HISTORIC AND DESIGN REVIEW COMMISSION

January 15, 2025

HDRC CASE NO: 2024-339
ADDRESS: 418 FLORIDA ST
319 E CAROLINA ST
LEGAL DESCRIPTION: NCB 3011 BLK 9 LOT 20
ZONING: C-2, H
CITY COUNCIL DIST.: 1
DISTRICT: Lavaca Historic District
APPLICANT: David Ranjbar/Prime & Paradigm Construction, LLC.
TYPE OF WORK: Construction of a commercial structure and fuel canopy; site work
APPLICATION RECEIVED: October 01, 2024
60-DAY REVIEW: November 30, 2024 (Postponed to January 15, 2025, by applicant)
CASE MANAGER: Edward Hall

The applicant is requesting conceptual approval to construct a commercial structure with a detached fuel canopy on the vacant lot addressed as 418 Florida and 319 E Carolina, located within the Lavaca Historic District.

ARCHITECTURAL SITE PLAN

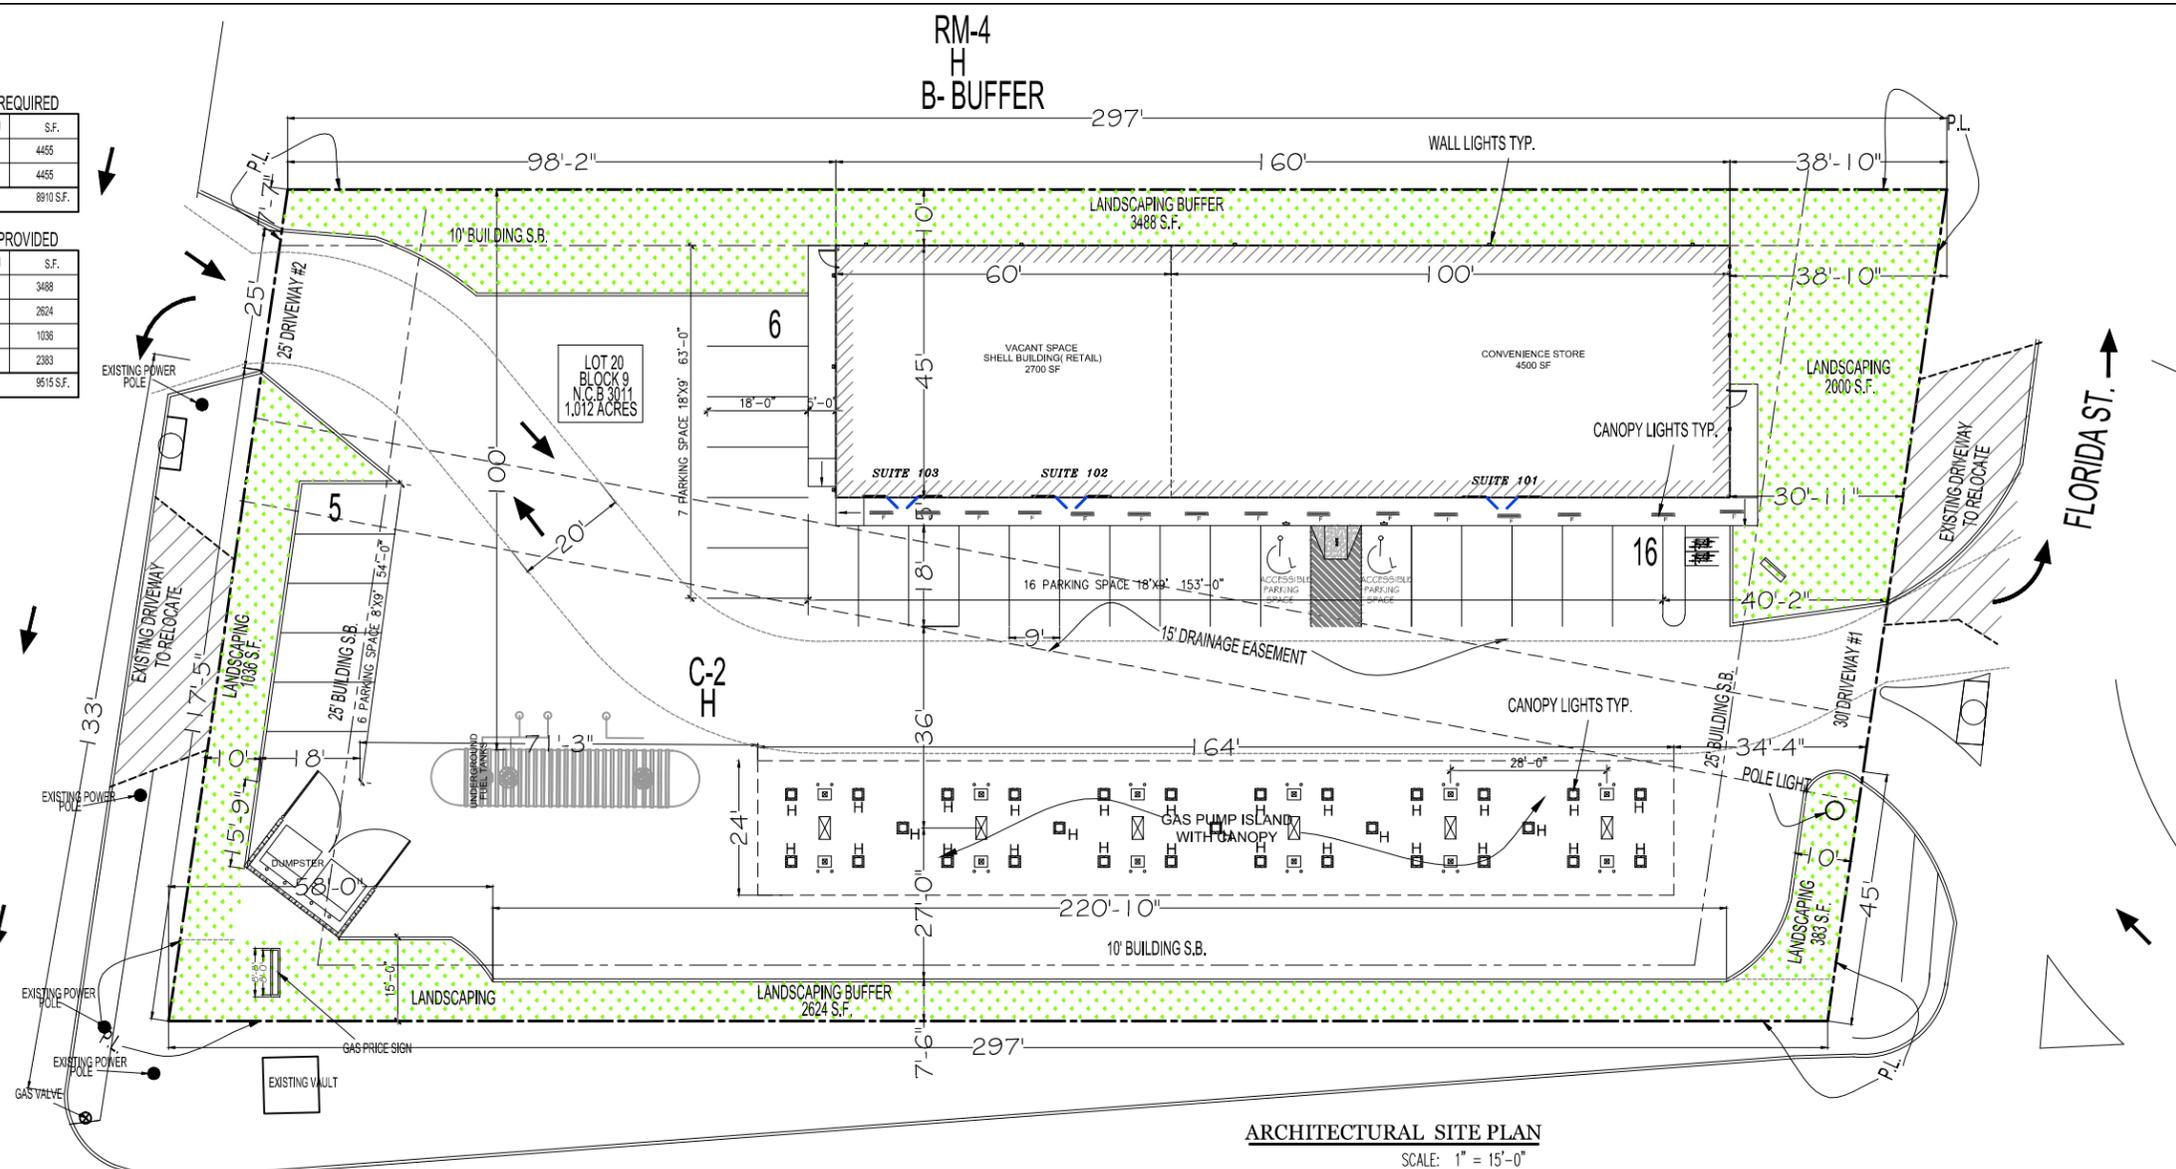
- t. FENCING/WALL – The applicant has noted a wall to feature between six (6) and eight (8) feet in height to separate the proposed new construction from neighboring, single-family historic structures to the west. The applicant has note shown the proposed fencing/wall element on the site plan. Staff finds that construction documents should be developed for the proposed wall, and that it should be shown on the site and landscaping plan.

- xi. That tall, evergreen shrubs or trees that screen the commercial use from residential properties should be incorporated into the landscape plan.
- xii. That construction documents should be developed for the proposed wall, and that it should be shown on the site and landscaping plan, as noted in finding t.

FRONT ELEVATION

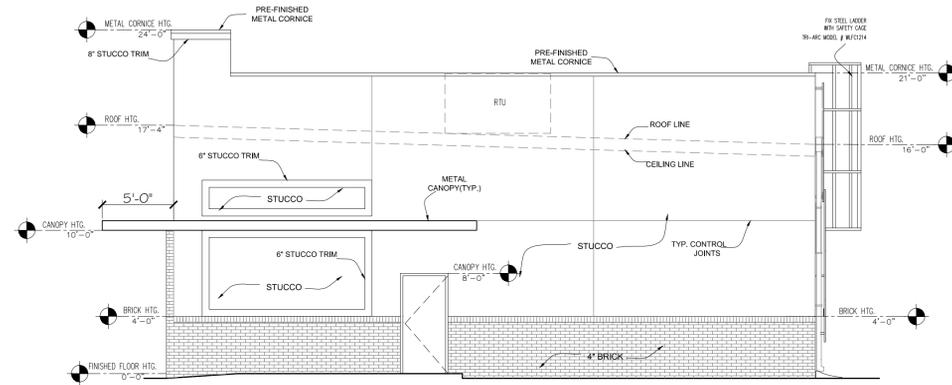
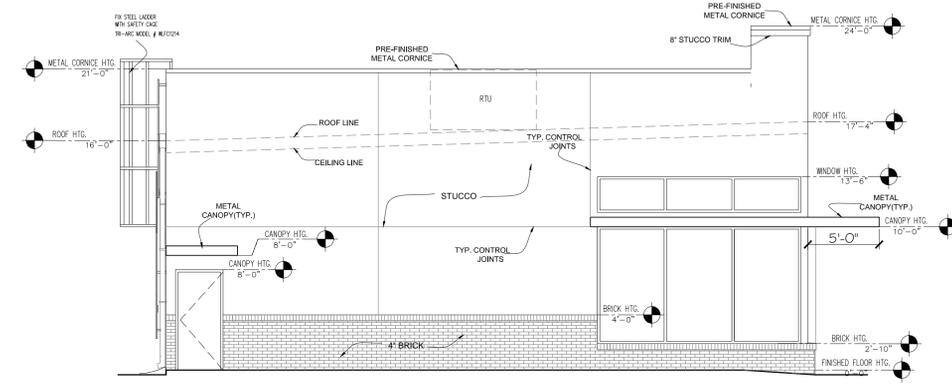
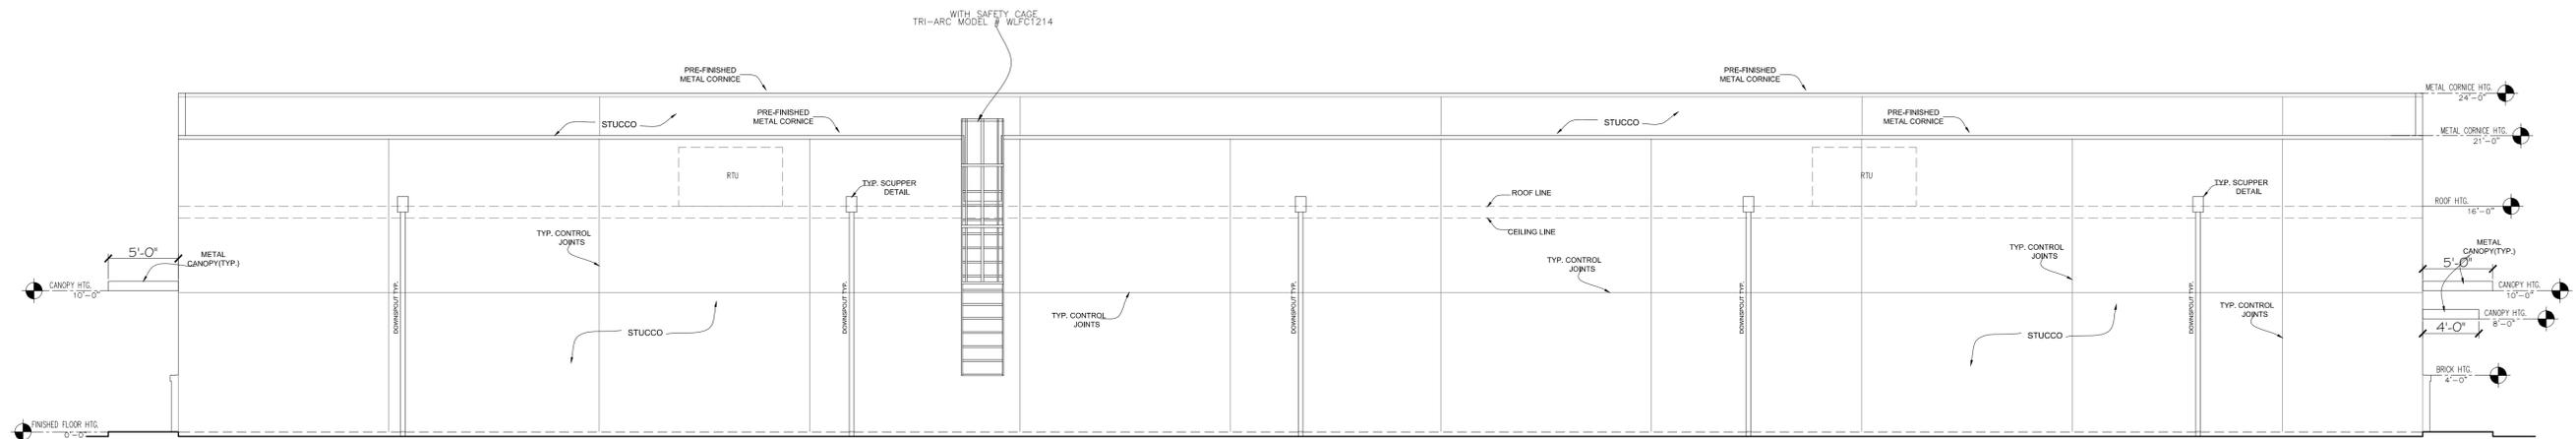
- k. **FENESTRATION PROFILE** – The applicant has proposed fenestration that consists of a storefront system with transom windows. Generally, staff finds the proposed approach to fenestration to be reflective of fenestration found on historically on commercial structures within the Lavaca Historic District. Staff finds that the profiles of muntins, mullions and other storefront and transom frame elements should relate to those found historically on commercial structures within the Lavaca Historic District. Additionally, staff finds that fenestration should be added to the north facade, as facades front Florida that lack fenestration are not found historically on this block.

- v. That fenestration should be added to the north facade, as facades front Florida that lack fenestration are not found historically on this block, as noted in finding k.

JF: The horizontal banding creates a parapet on the east side of the building; please show rooftop equipment in elevations and to show how the equipment will be screened.

SITE LIGHTING PLAN
 SCALE: 1" = 15'-0"

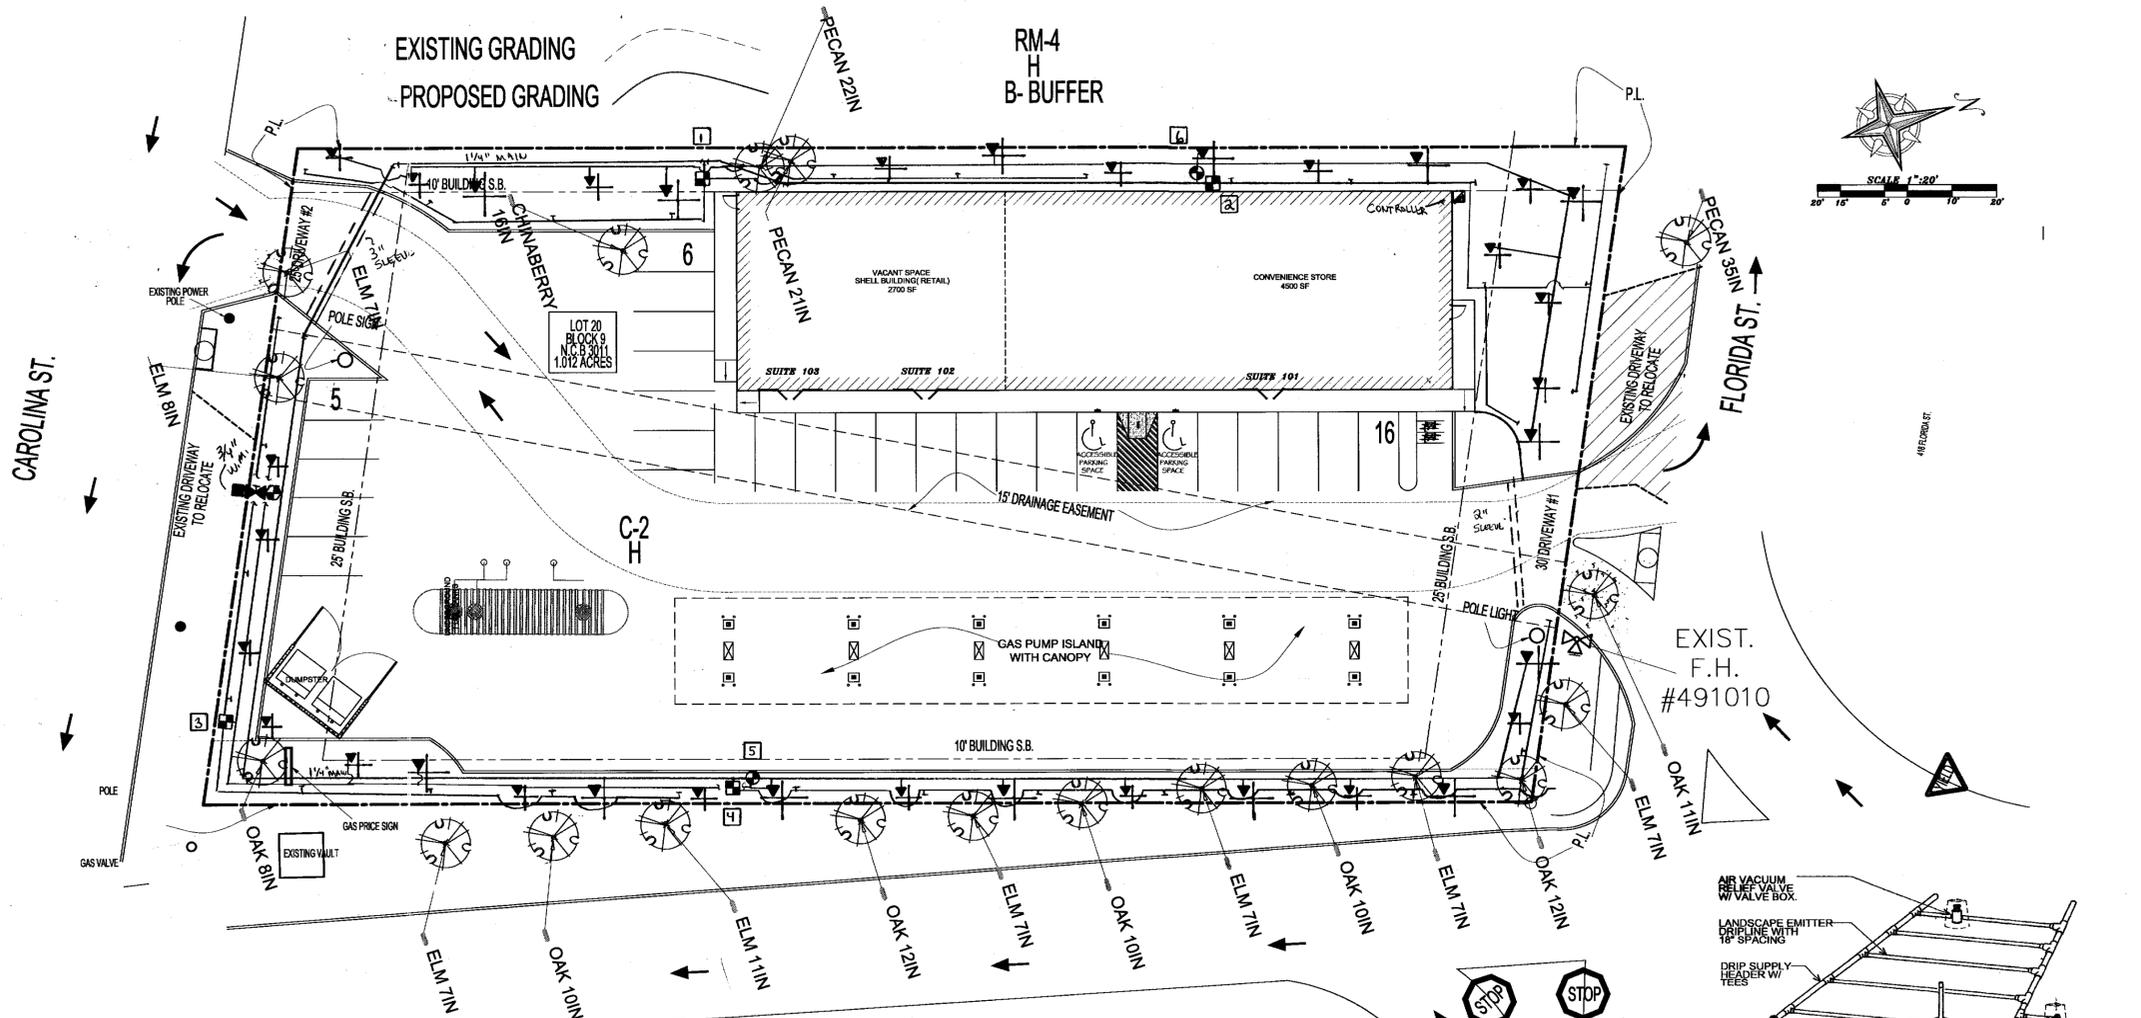
- o. SITE & ARCHITECTURAL LIGHTING – The applicant has submitted information regarding building and fuel canopy lighting. Staff finds that a detailed site and architectural lighting plan should be developed and submitted for review and approval when returning to the Commission for final approval. Lighting should be developed in a manner that does not result in light pollution.

- xiii. That a detailed site and architectural lighting plan be developed and submitted for review and approval when returning to the Commission for final approval. Lighting should be developed in a manner that does not result in light pollution.

LANDSCAPE PLAN

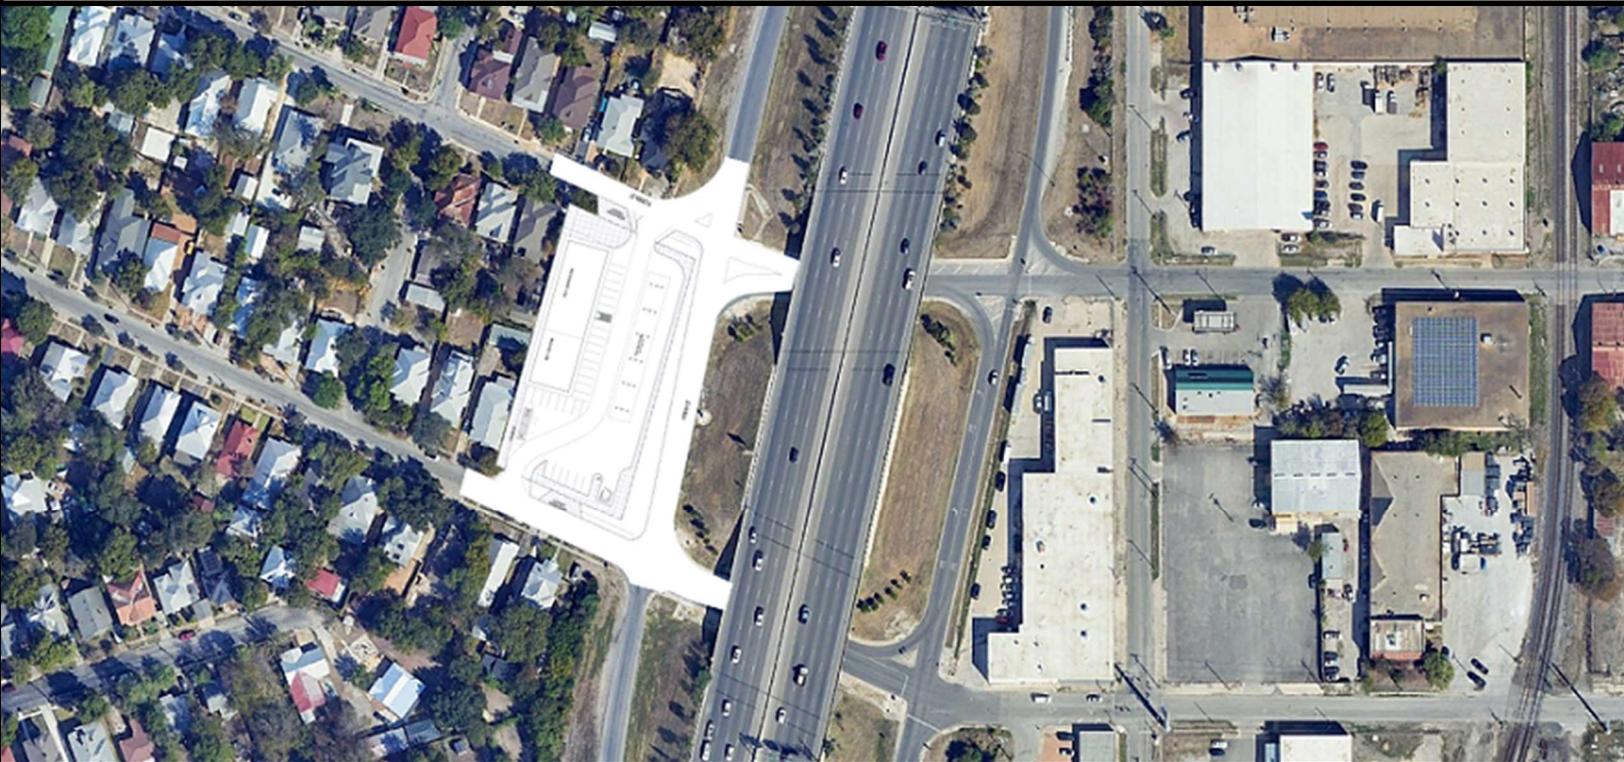
- m. LANDSCAPING – The applicant has provided a detailed landscaping plan; however, staff finds that all landscaping requirements of the Unified Development Code and the Historic Design Guidelines are to be met. This includes a minimum 15-foot buffer yard along the west property line between the building and the residential properties. Staff finds that the building setback should be increased to 15 feet, as required by the UDC, and that tall, evergreen shrubs or trees that screen the commercial use from residential properties should be incorporated into the landscape plan.
